**CITY OF MENIFEE
DEPARTMENT OF PUBLIC WORKS
CONTRACT CHANGE ORDER NO. 04**

HOLLAND ROAD OVERCROSSING

RFI #031 – Post Tension changes

DETAIL 1- DUCT LAYOUT
(INTERIOR GIRDER)

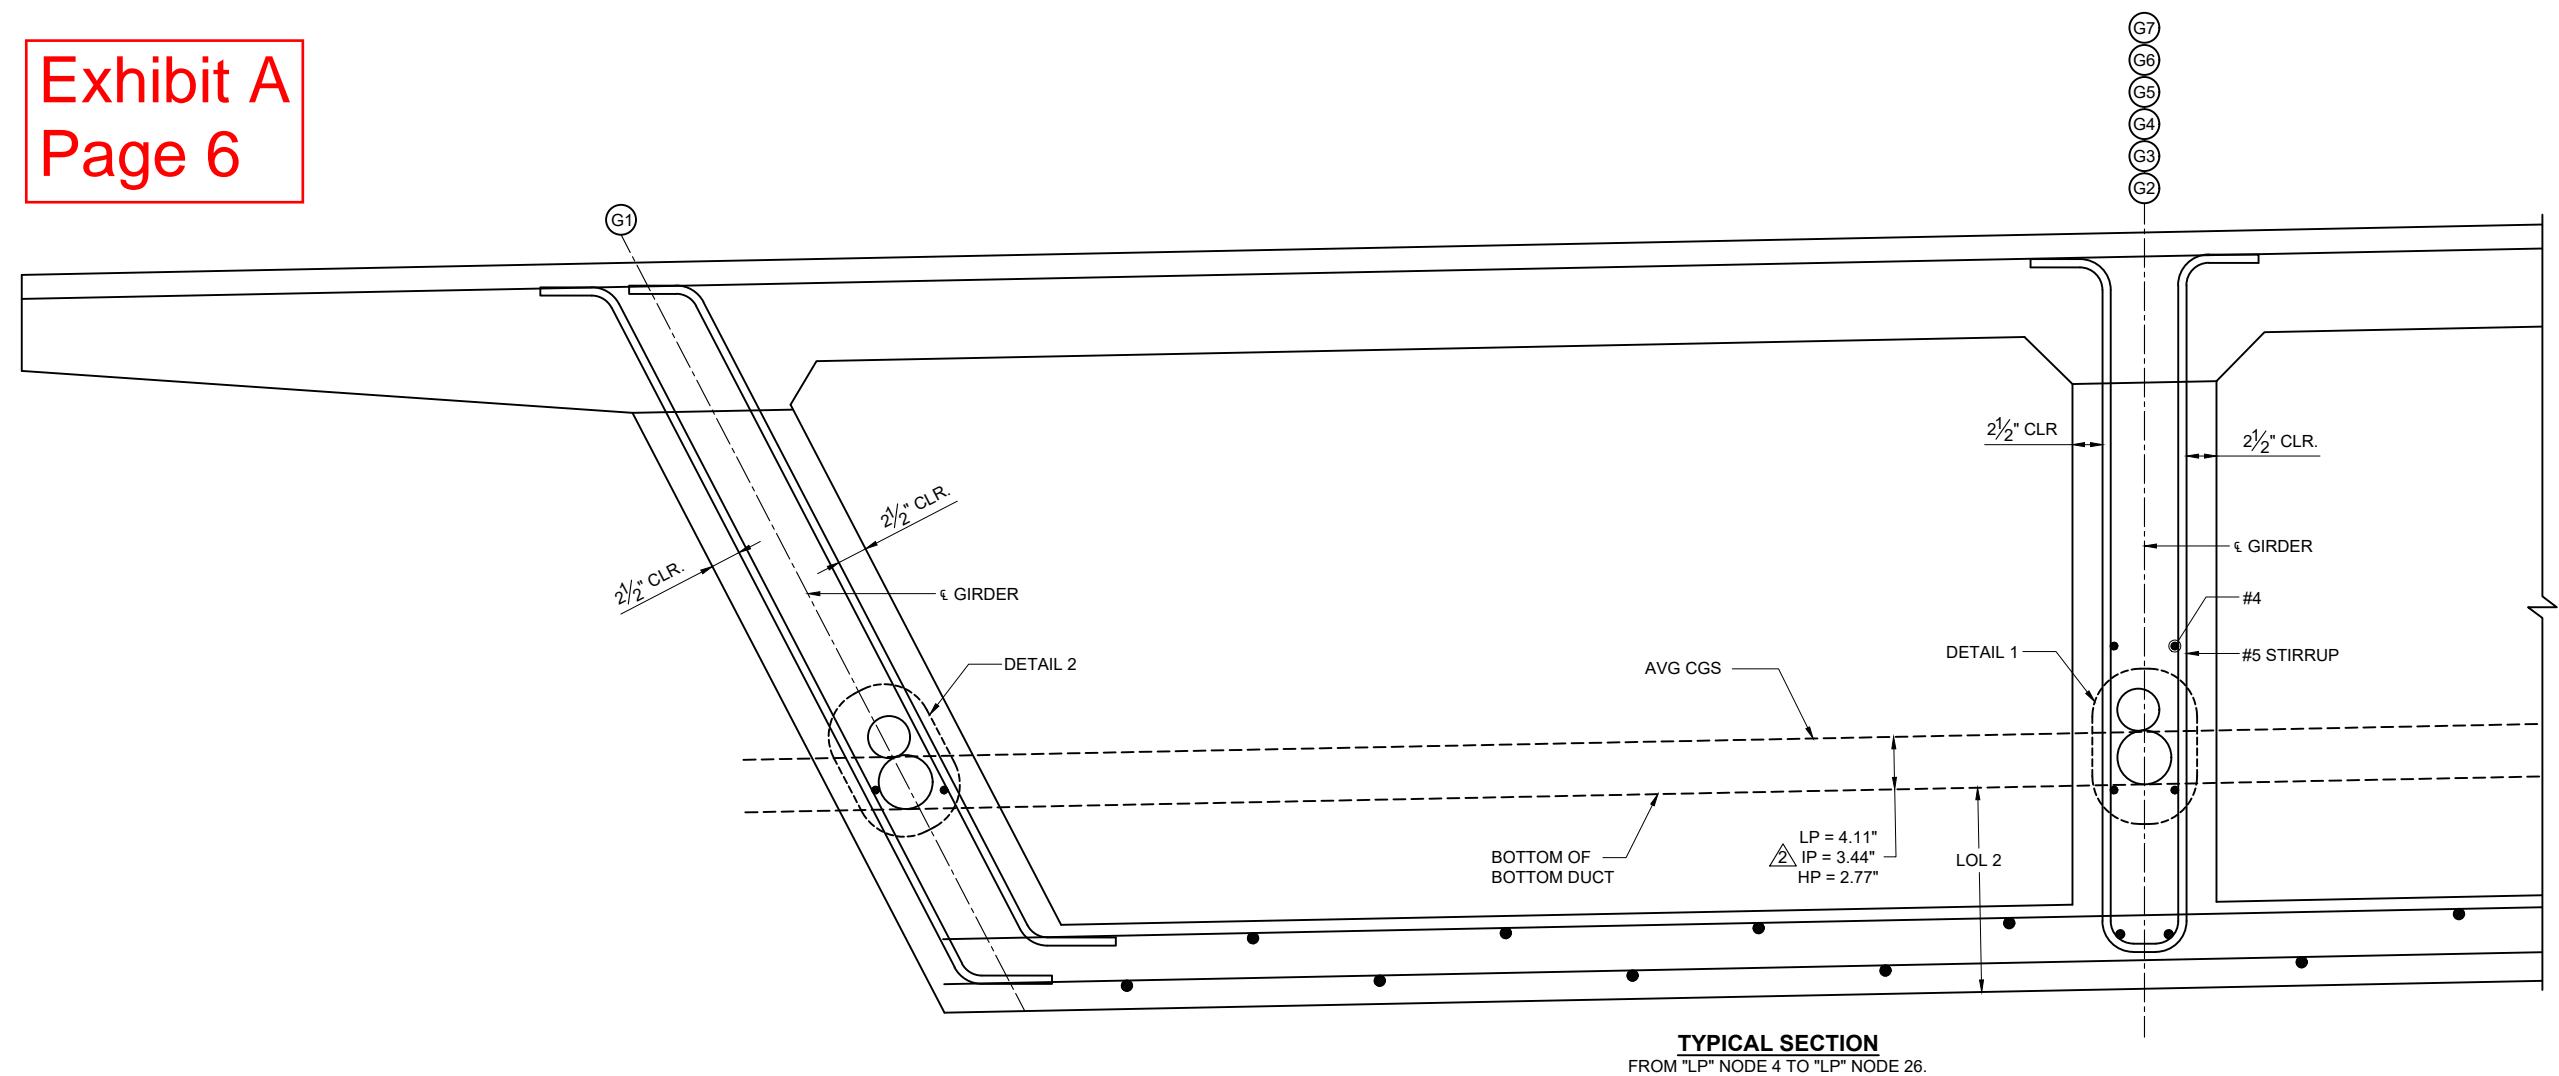
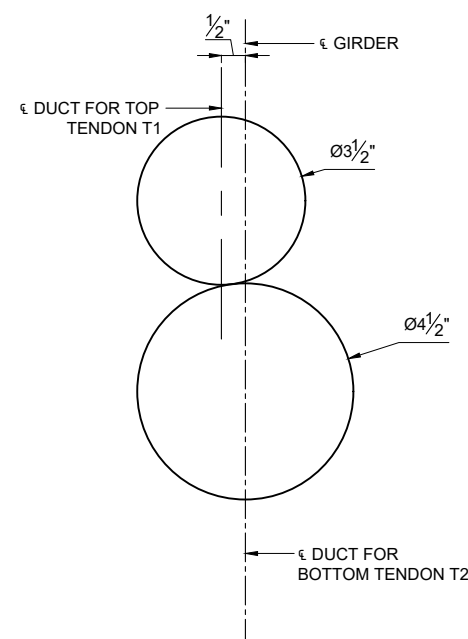
*GIRDER FLARE THICKNESS OF 18" AT ABUTMENT 1 AND 4 FOR INTERIOR AND EXTERIOR GIRDERS IS NOT ENOUGH FOR ANCHORS TO FIT AND PERFORM SINCE THE DIAPHRAGM AT EACH ABUTMENT IS ONLY 3'-0" DEEP. **WE RECOMMEND ENLARGING FLARE THICKNESS TO 20" FOR INTERIOR GIRDERS AND 22" FOR EXTERIOR GIRDERS.** ADDITIONAL CONCRETE REQUIRED, BY OTHERS.

**POST TENSIONING LAYOUT
PROFILE AND SUPPORT HEIGHT**

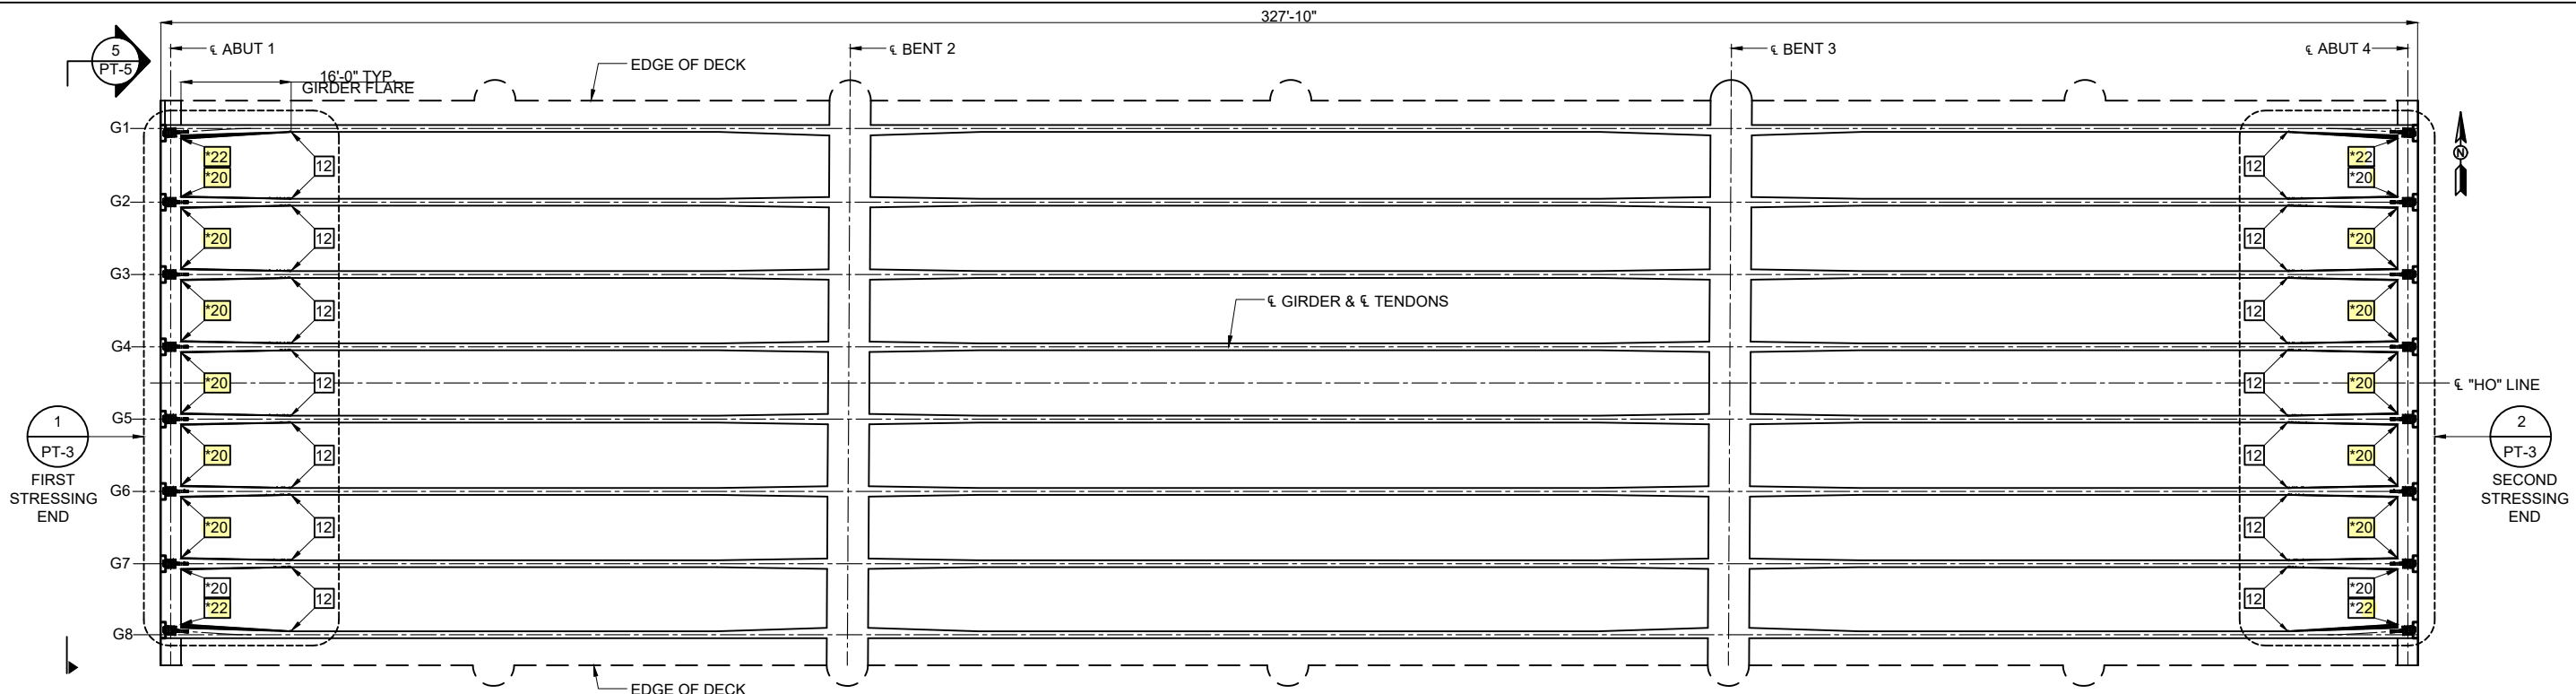
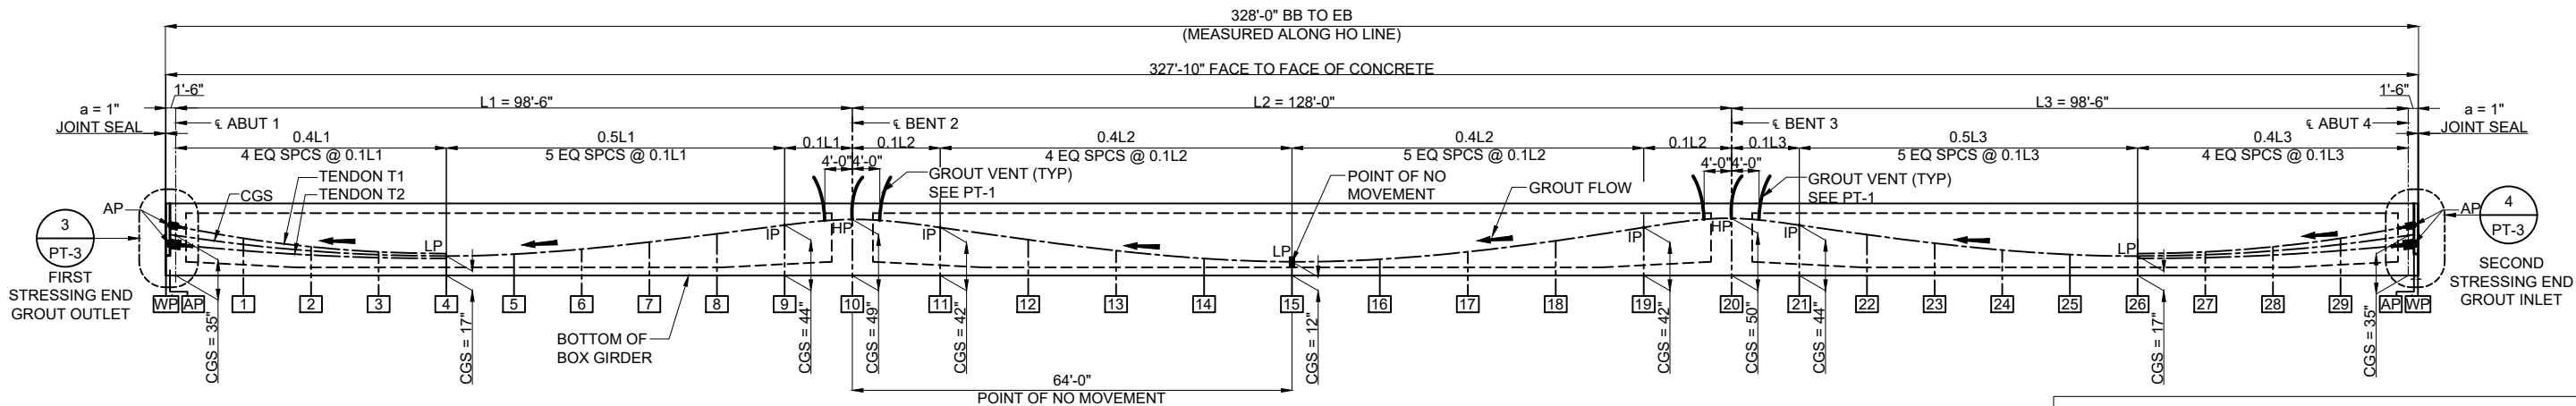
Per Plan sheet 126 of 176, the Girder flares are noted as 18". We are requesting to change flare thickness to 22" on exterior and 20" on interior. See attached highlighted plans showing the original and the proposed. Please review and approve at your earliest convenience.

CONTRACTOR MAY ELECT TO
REVISE THE ANCHORAGE DETAIL
PER ATTACHED SHOP DRAWINGS
WITH NO EXCEPTIONS

"The changes associated with RFI 31 is at the request of the Contractor at no cost to the City. CCO 4 at (No cost - No credit) will be issued to cover this change."
